**ADDENDUM NO. 2**

**CITY OF ABERDEEN  
ZONE 3 ELEVATED WATER TANK  
CONTRACT NO. 22-05**

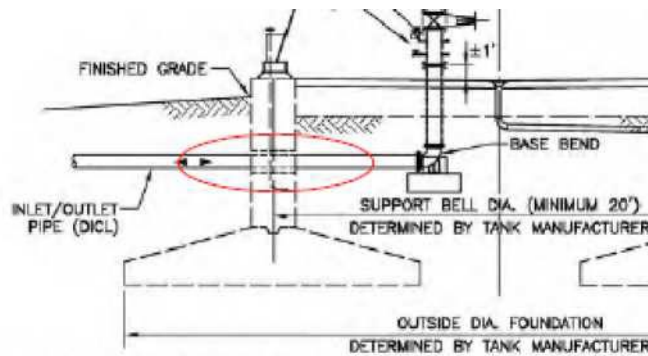
Form system shall incorporate a uniform pattern of vertical and horizontal rustications to provide architectural relief to the exterior wall surface.

Proportion vertical and horizontal rustications and form ties to impart a symmetrical architectural pattern.

No architectural form treatment is required on the interior surface.

*Noted: A revised Specification Section 13211 Composite Elevated Potable Water Tank will be provided, which includes design standards that were provided by the manufacturer.*
